**HAYSVILLE PLANNING COMMISSION  
& BOARD OF ZONING APPEALS**

## Haysville Planning Commission Staff Report

**Subject:** Final Plat 2023-05 “P.J. Branch Addition”  
**Applicant/Agent:** Mr. Paul Branch/ Mr. Harlan Foraker  
**Request:** Plat of the Northwest Quarter of Section 17, Township 29 South, Range 1 East of the 6<sup>th</sup> Principal Meridian, Sedgwick County, Kansas.  
**Site Size:** 7.09 acres  
**Zoning:** Residential  
**Location:** SE corner of the intersection of W. 87<sup>th</sup> St. S. & Sence Dr. Haysville, KS 67060  
**Meeting Date:** September 28, 2023  
**Presented By:** Jonathan Tardiff, Planning and Zoning Administrator

Response from Utility Companies on Plat review of “P.J. Branch Addition.”

# FINAL PLAT P.J. BRANCH ADDITION

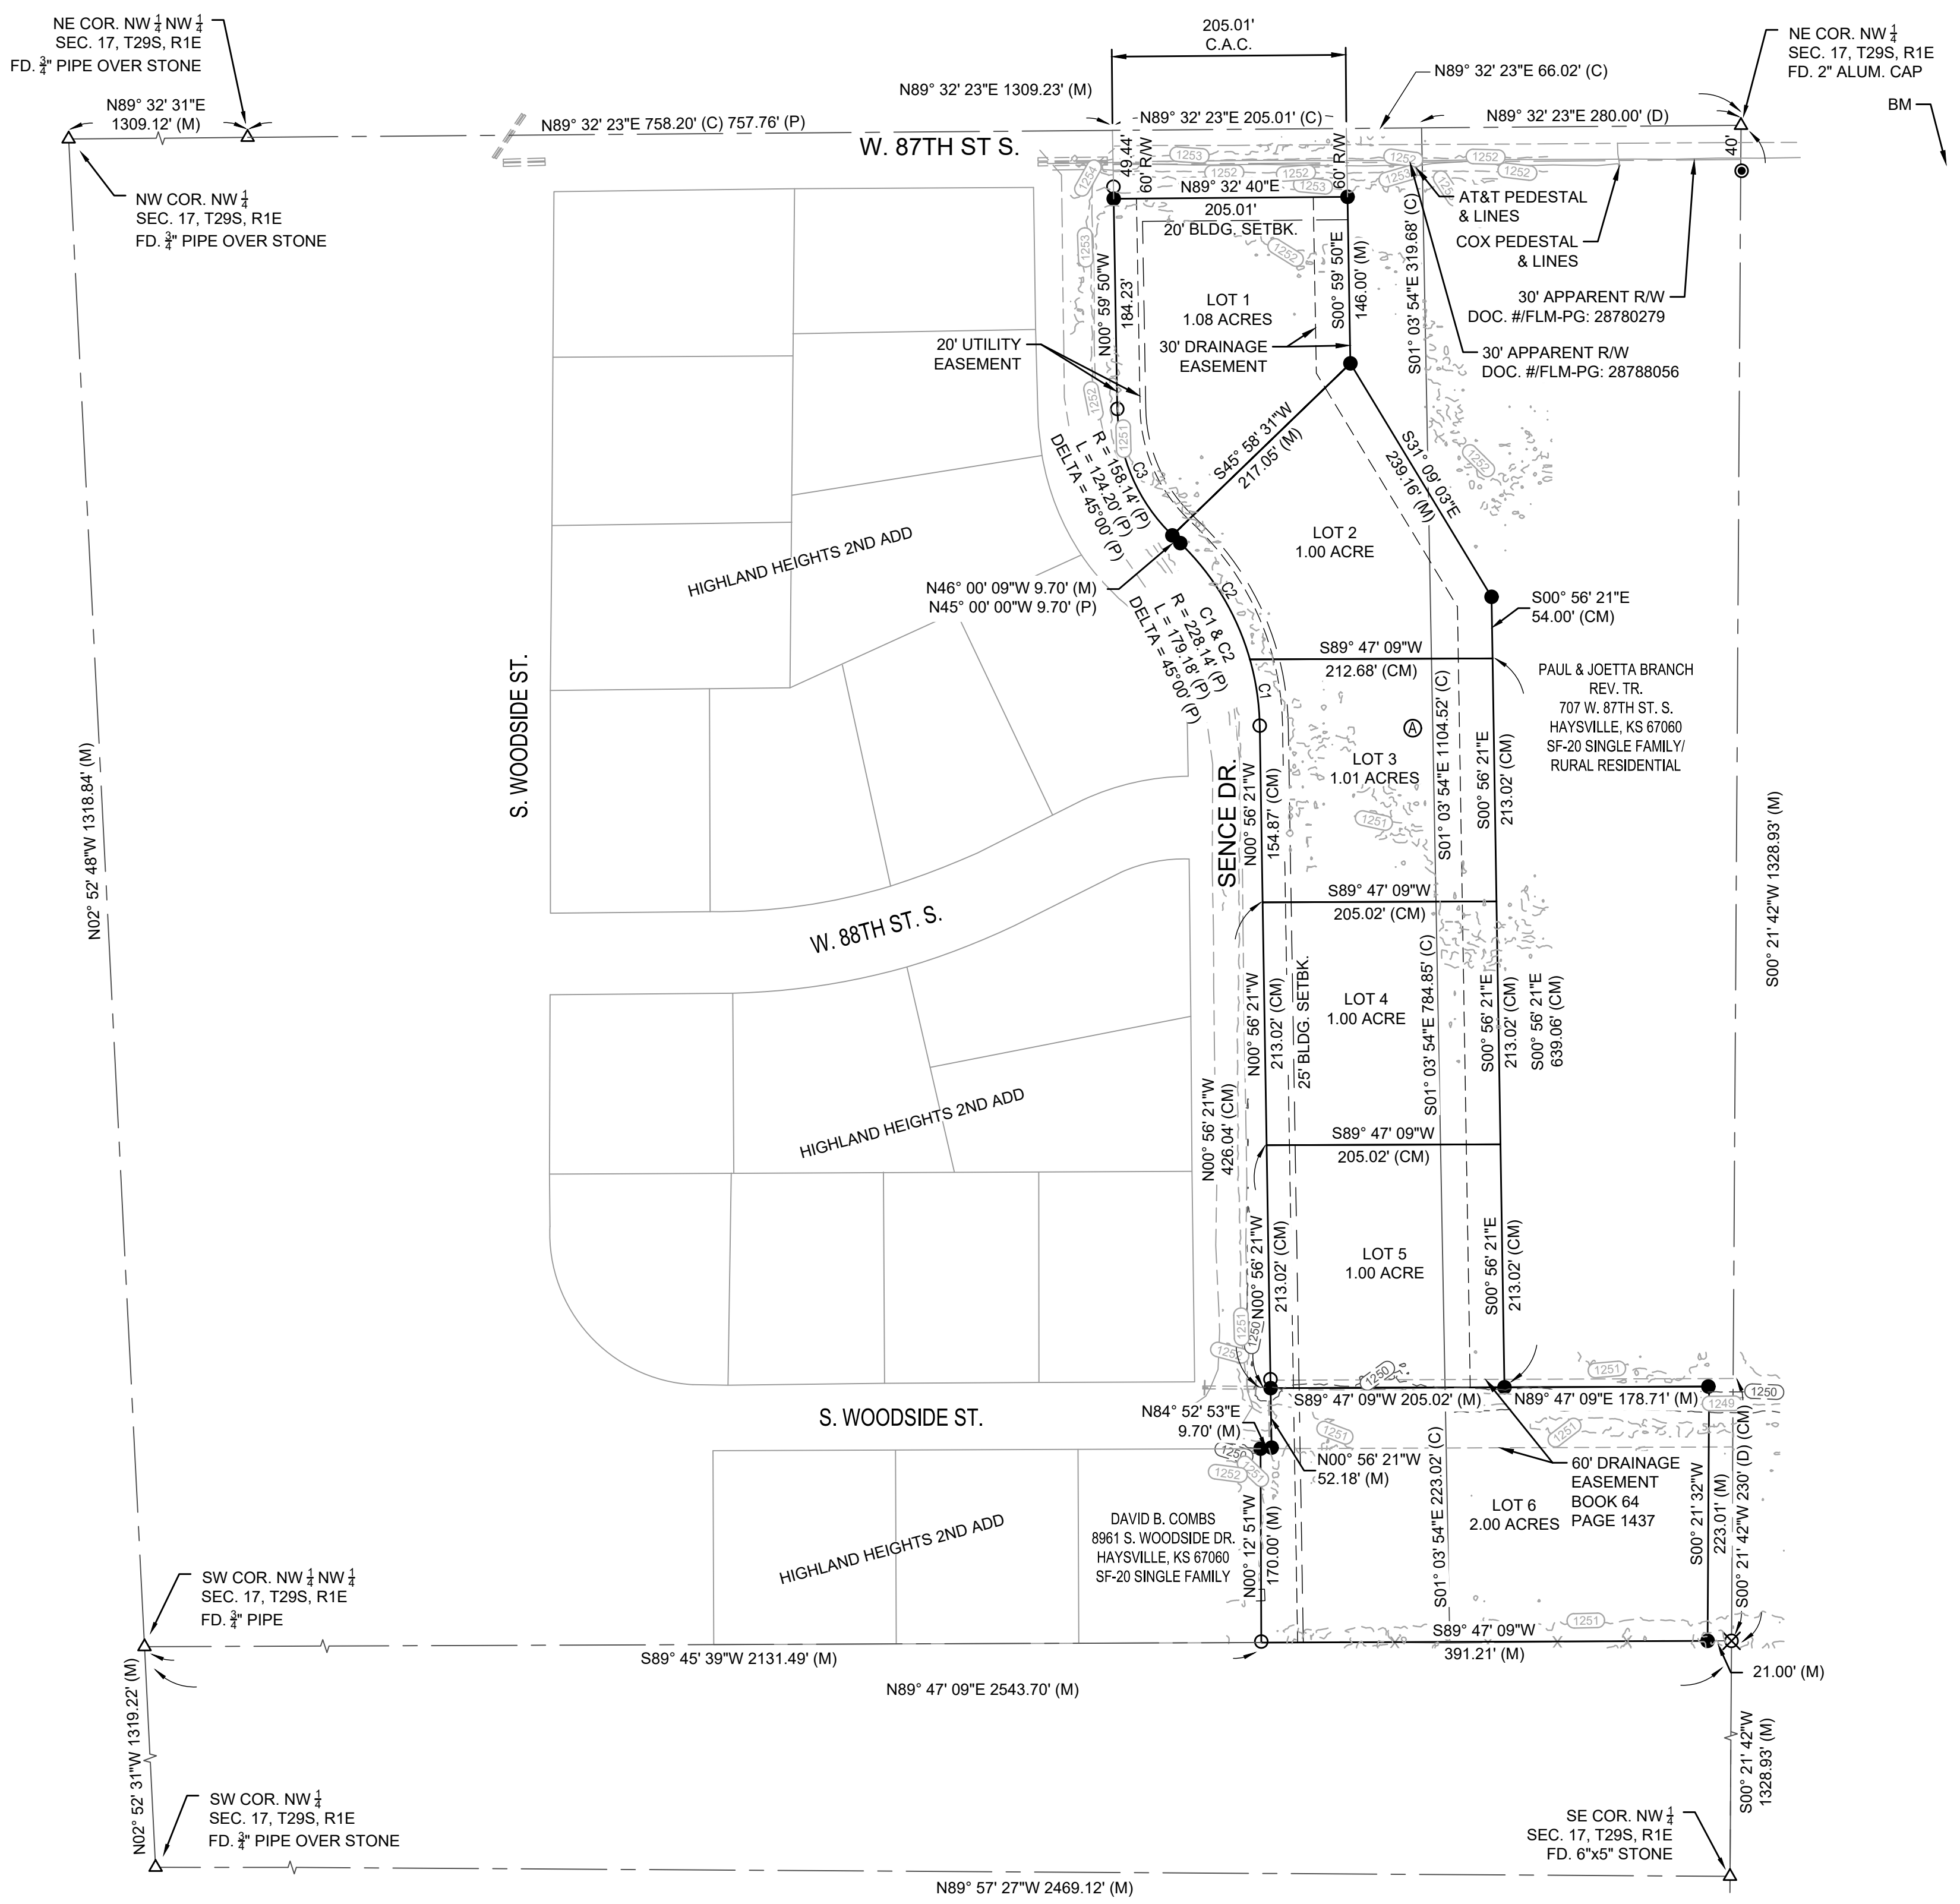
- Final Plat
    - Add notary certificates for Branch Enterprises, Lucy Capps, and Jon D. Zobel, Jr.
    - It appears that the minimum pad elevations are set based on the BFE of Cowskin Creek located to the east. Sedgwick County Public Works needs to comment on the appropriateness of the elevations listed.

- The street name on the west side of the subject plat is platted Autumn Lane, not Sence Dr.
    - Add overall dimensions of perimeter boundary (East line of Lots 2-5 and West line of Lots 3-5).

- Show details of the 60' Drainage Easement located and labeled between Lots 5 and 6. (Book 64, Page 1437).
    - Add C.A.C. to the legend to denote Complete Access Control.

- Would like a copy of the Drainage Report to review.
    - Clarify the dimension on the west line of Lot 5 (two monuments shown at the Southwest corner of the lot).

# PRELIMINARY PLAT P.J. BRANCH ADDITION

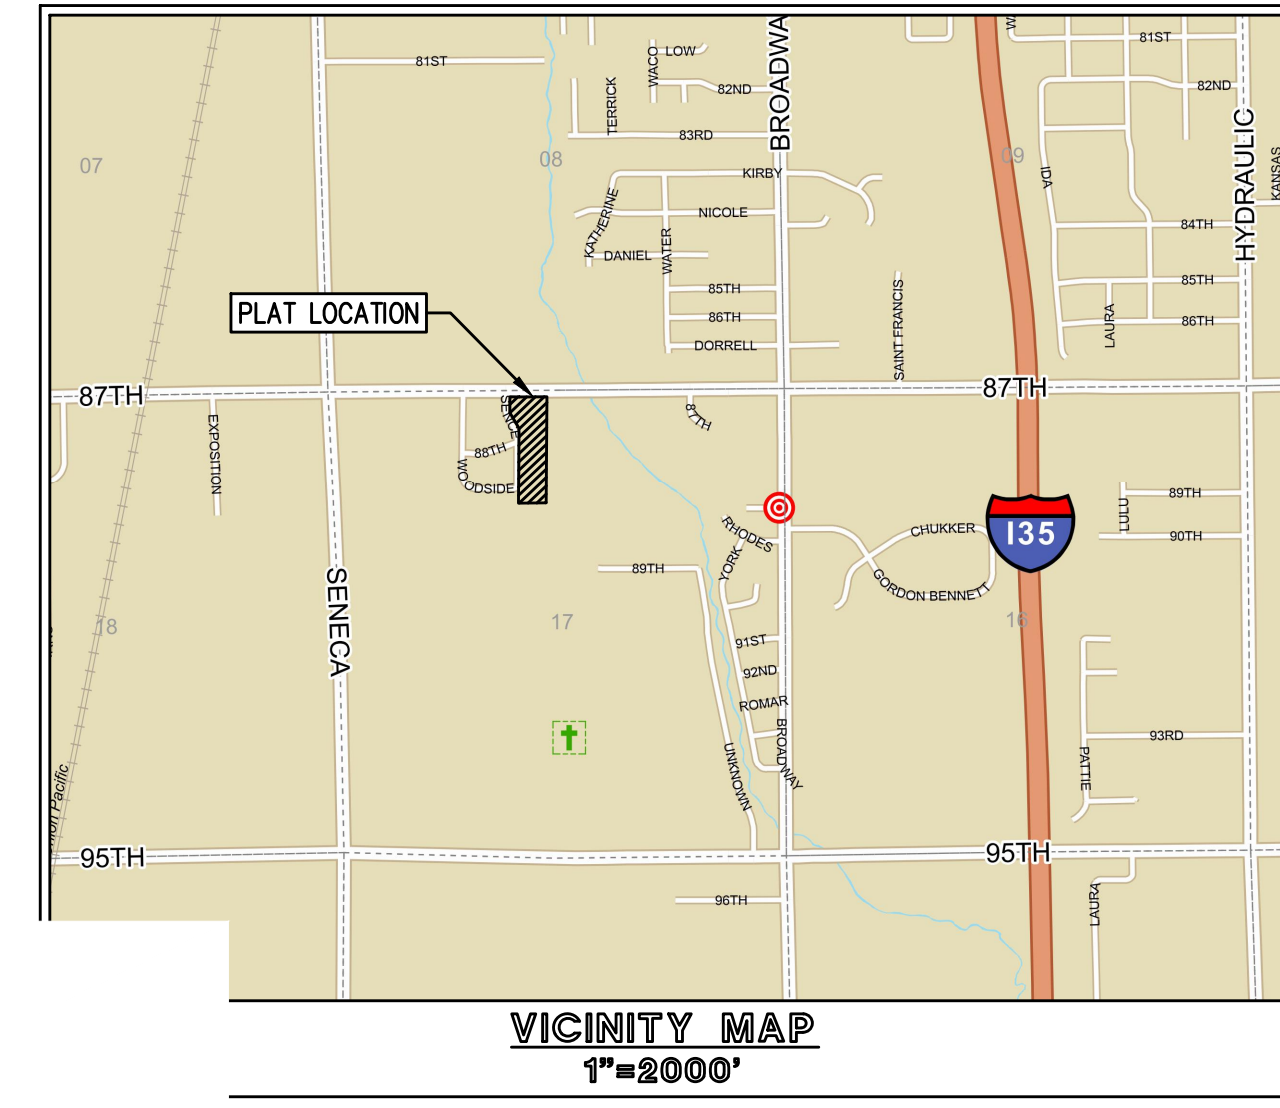
- PEC has the following remarks:
  - Preliminary Plat
    - Show lots and streets of Highland Heights 2<sup>nd</sup> Addition west of subject plat.
    - The street name on the west side of the subject plat is platted as Autumn Lane, not Sence Dr.

- Add overall dimensions of perimeter boundary (East line of Lots 2-5 and West line of Lots 3-5).
    - Add note that the subject property is in the FEMA Floodplain.
